LR-N10-0165

Salem Nuclear Generating Station, Unit No. 1 and Unit No. 2
Facility Operating License Nos. DPR-70 and DPR-75
NRC Docket Nos. 50-272 and 50-311

Subject: Response to NRC Request for Additional Information dated April 15, 2010, Related to Structures and Structures-Related Aging Management Programs for the Salem Nuclear Generating Station, Units 1 and 2 License Renewal Application

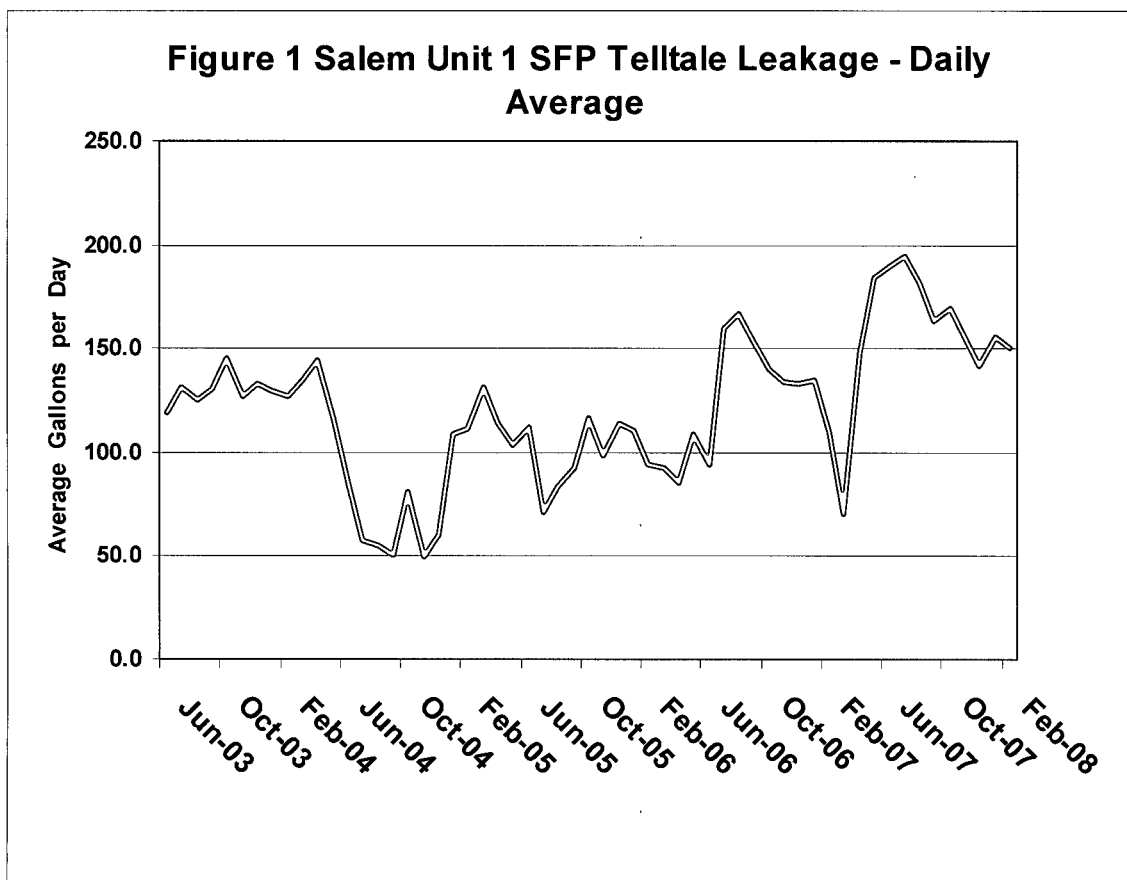
- a. Provide historical data on the leakage occurrence and volume, and available information from chemical analysis performed on the leakage.
- b. Provide a summary of the root cause analysis that was used to identify the source of leakage through the liner that has resulted in accumulation of borated water between the liner and concrete, including information on the path of the leakage and structures that could potentially be affected by the presence of the borated water.

In 2003, Salem began monitoring and trending leakage through the telltales. The volume of leakage varies as indicated in Figure 1 below but on an average is approximately 100 gallons per day. This figure shows average daily leakage up to February, 2008. Based on sump pump run times, daily telltale leakage rates have remained approximately the same for 2008, 2009 and early 2010. The trends of leakage through the telltales are used as an indicator that corrective actions are required to maintain proper drainage through the leak chase system, thus, preventing buildup of borated water between concrete and the liner.

Figure 2 - Extrapolation of Degradation through End of Plant Life

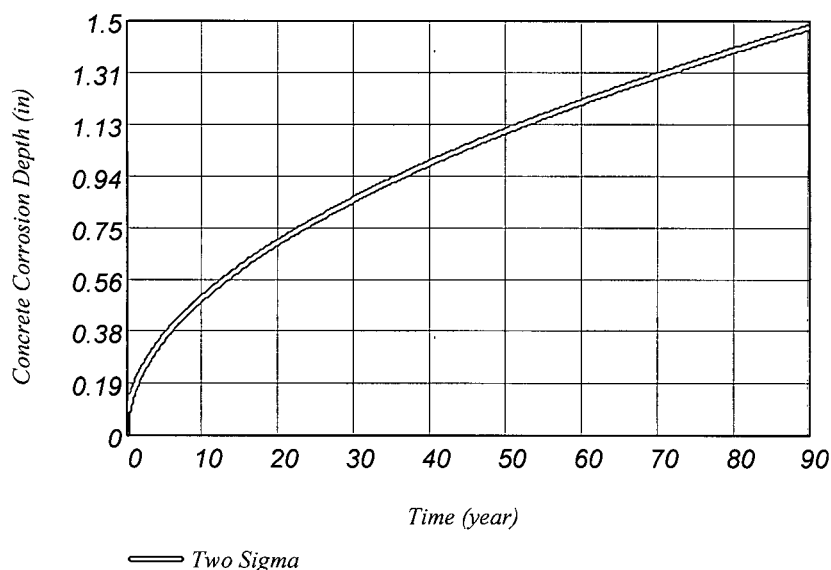
- d. Provide background information and data to demonstrate that the concrete and embedded steel reinforcement have not been degraded by exposure to the borated water and that the liner will not be impacted. If experimental results will be used as part of the assessment, provide evidence that the test program is representative of the materials and conditions that exist in the region between the spent fuel pool liner and concrete. This information should also include the MPR Associates report that documents the details of the tests performed and evaluation of SNP spent fuel pool concrete and rebar.

Beginning in 2003 a series of borated water degradation tests were conducted on core samples taken from the Salem Auxiliary Building and new concrete specimens that were made to the original Salem specifications using aggregate from the original sources. Concrete test specimens were submerged in a borated water bath for varying periods up to 39 months. The borated water bath testing parameters (borated water concentration and temperature) were maintained to be representative of the SFP water. The tests were conducted in a manner which was conservative with respect to the actual conditions expected in the FHB. Test specimens were removed from the bath at periodic intervals and degradation of the exposed concrete surface was measured. Results show that degradation is diffusion-controlled, which is consistent with published studies of weak acid attack of concrete. A curve fit of degradation versus time was generated using the measured degradation from test specimens. The following figure 2 shows the curve fit.
